STATION HILL

READING

AMENDMENTS TO RMA REF:
190465 PLOT E

NOV 2019

1 Site - Garrard Street Elevation Plots F and E
1 : 250

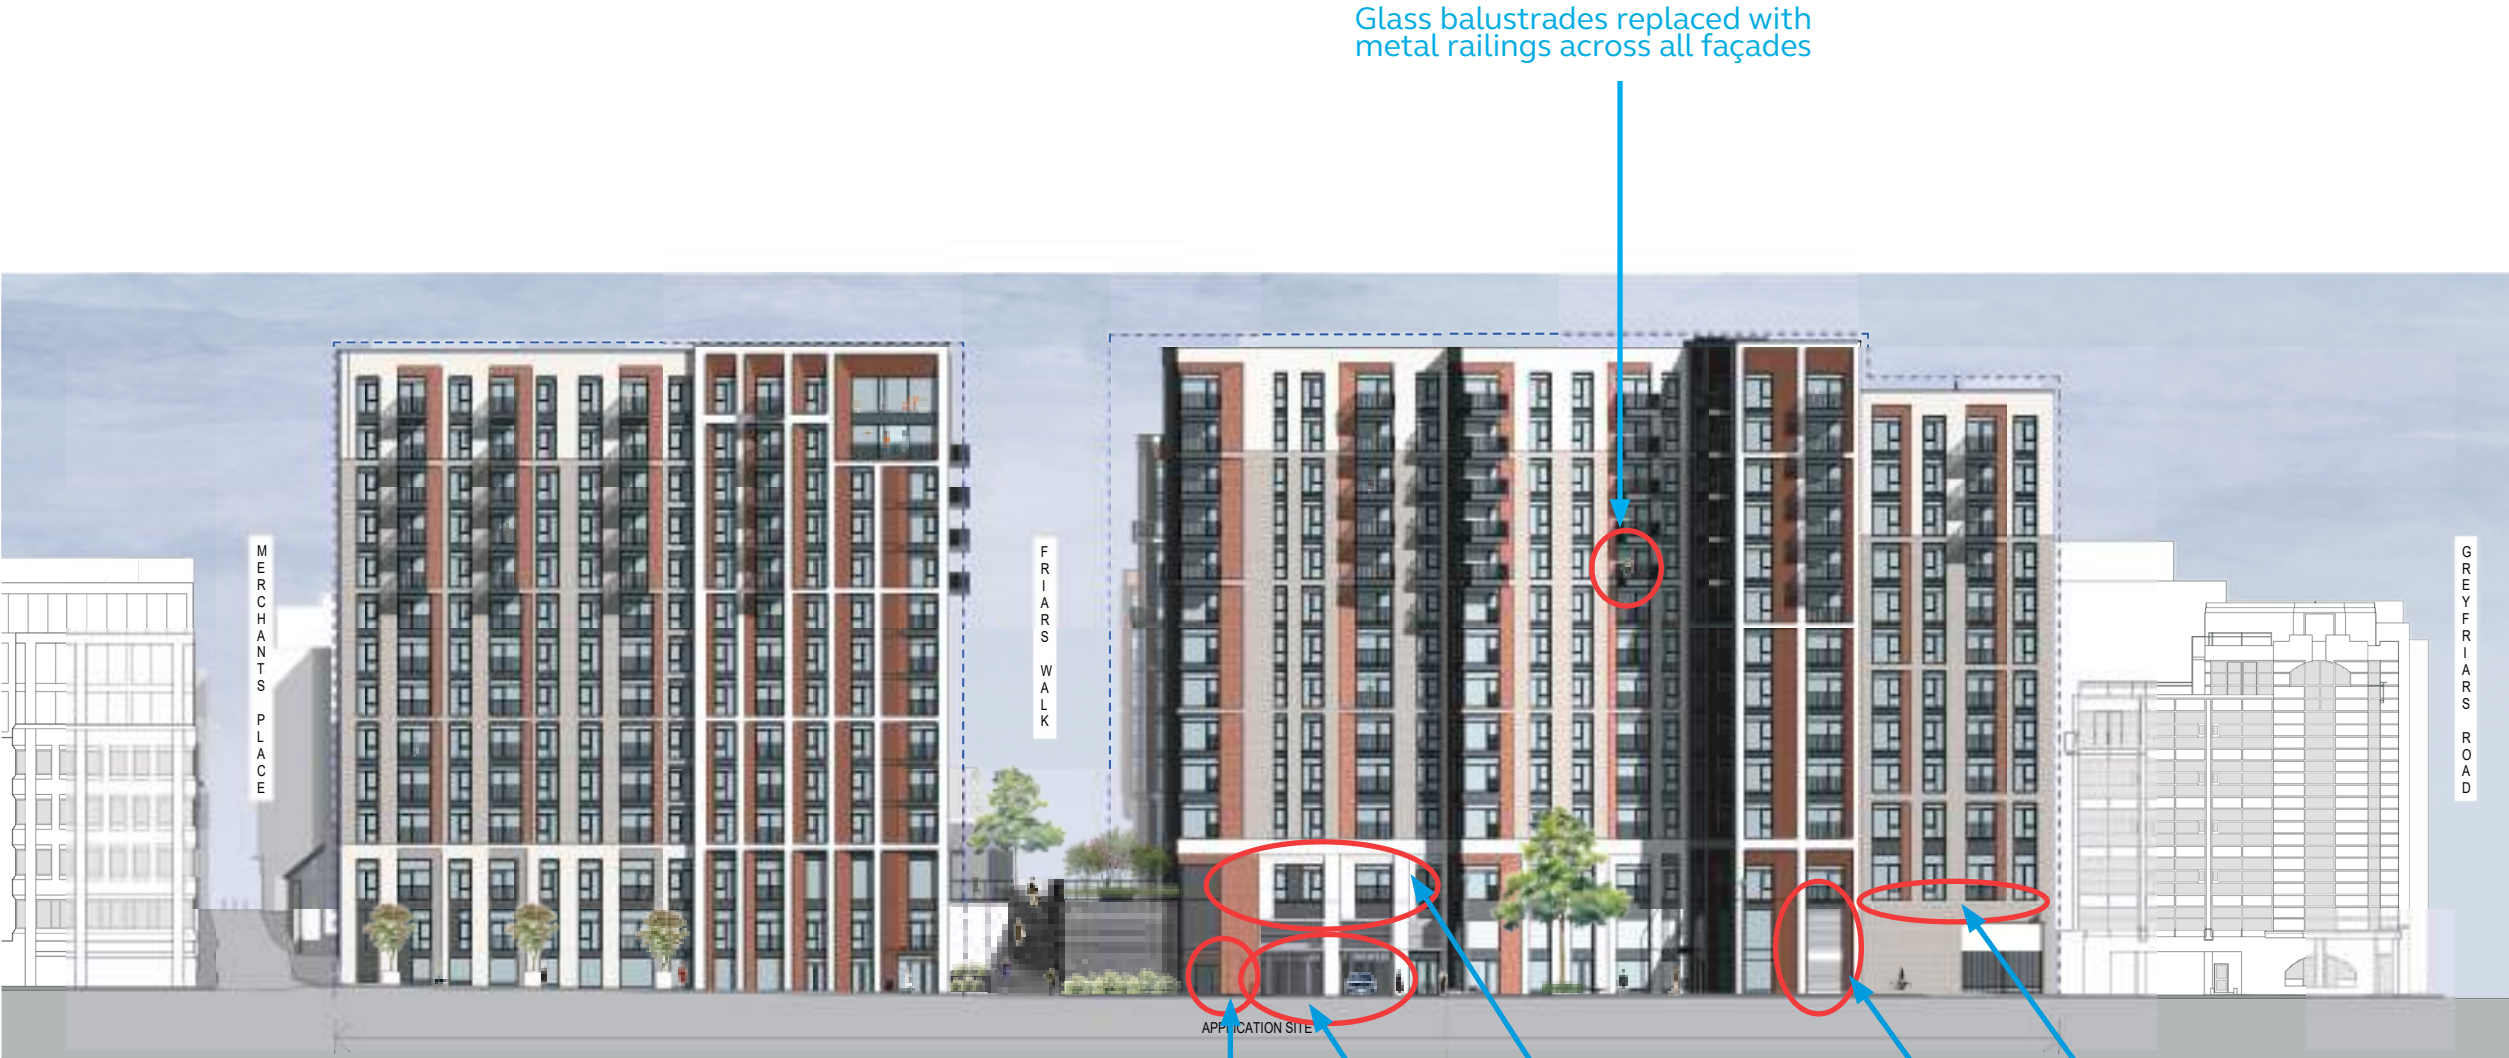
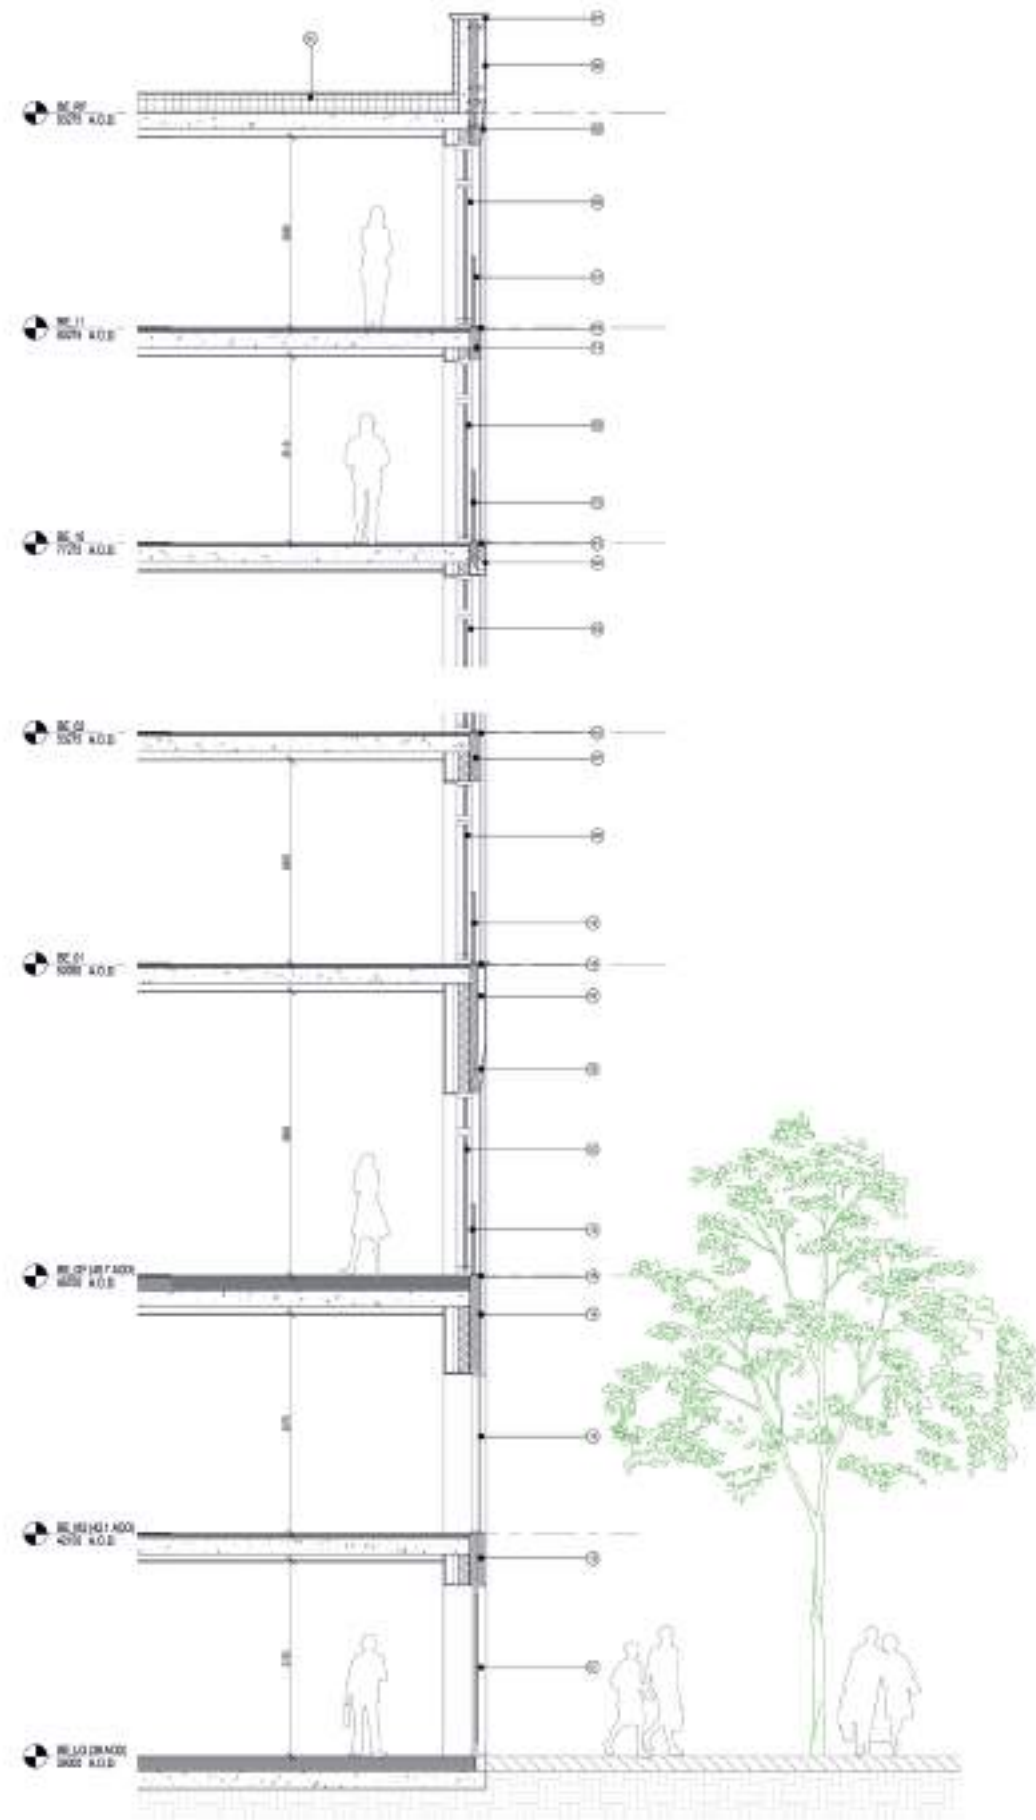
Brick hit and miss panel to provide screening to louvre to plant room behind.

GRC panel with horizontal slotted openings to provide screening to car park louvres.

Bi-folding car park entrance doors in place of roller shutters.

Aluminium spandrel panel omitted for brickwork.

GRC panel with horizontal slotted openings to provide screening to plant louvre.

**Plot E Elevations - East
and West**

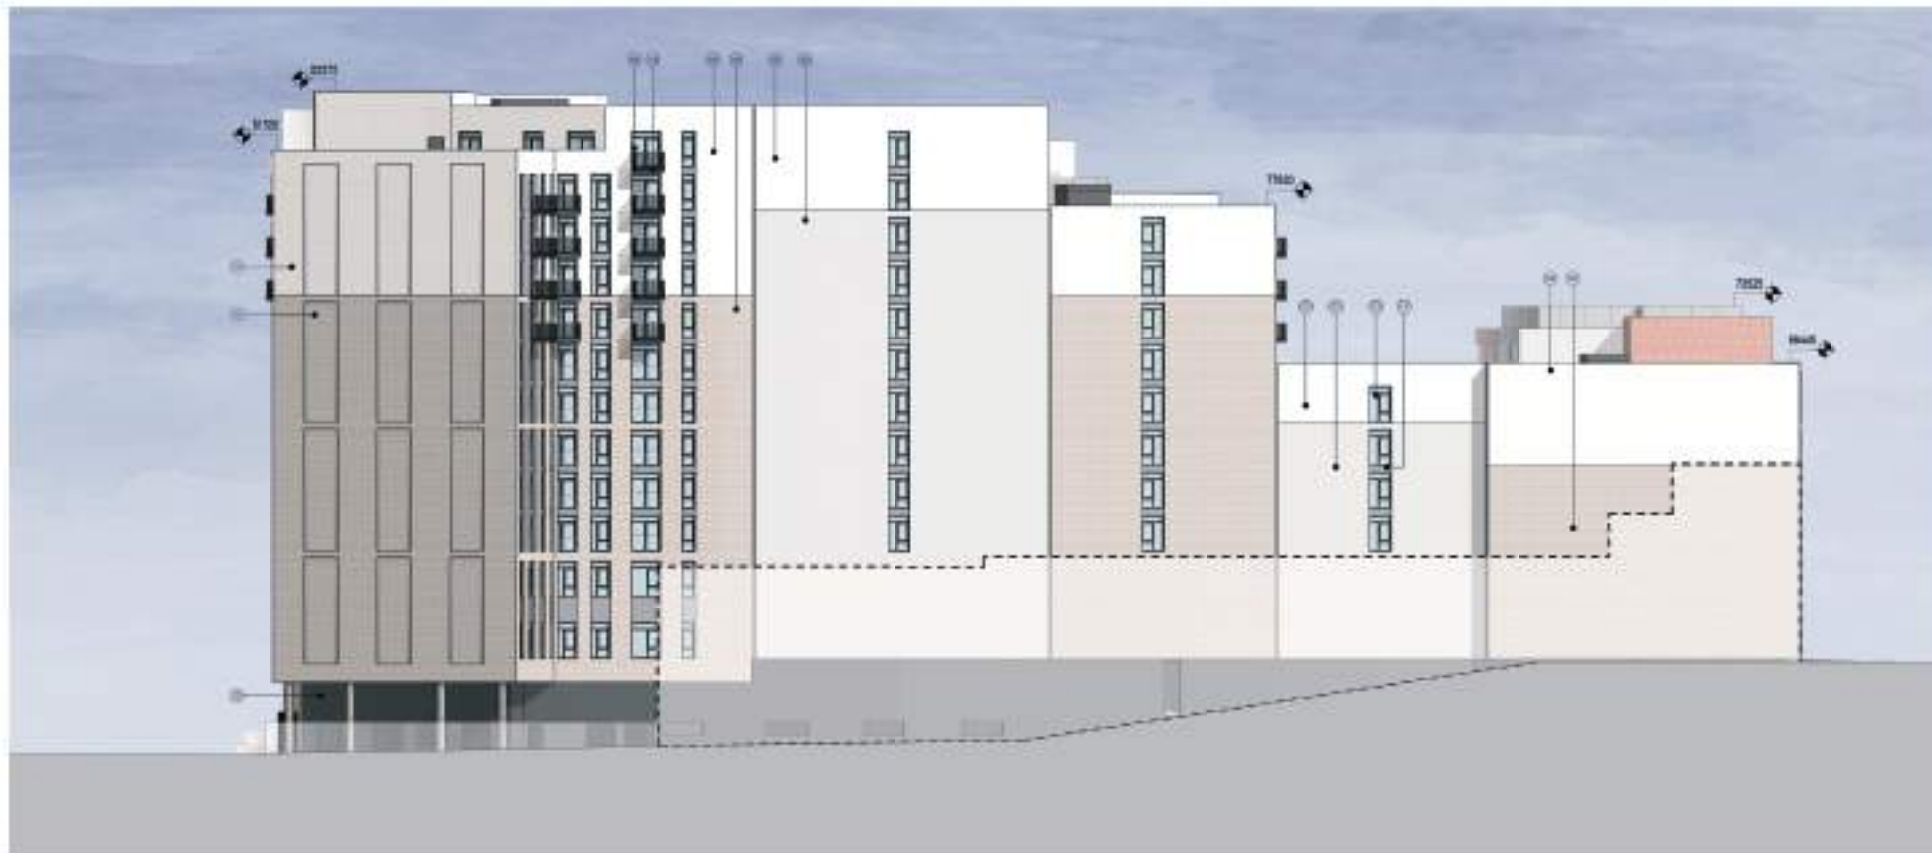
Additional louvres at lower ground floor and mezzanine level are now shown to the western façade in-line with the car park ventilation strategy and grey render panels are replaced with red brickwork.

Along friars walk the shop front elevation, railings have been omitted to allow brickwork to continue up for form parapet and timber cladding to façade has been omitted and additional canopy provide over new entrance door. Grey zinc panelling to the mid core is extend down to ground floor level in lieu of glazing.

At level 6 a glass balustrade has been added to the roof terrace.
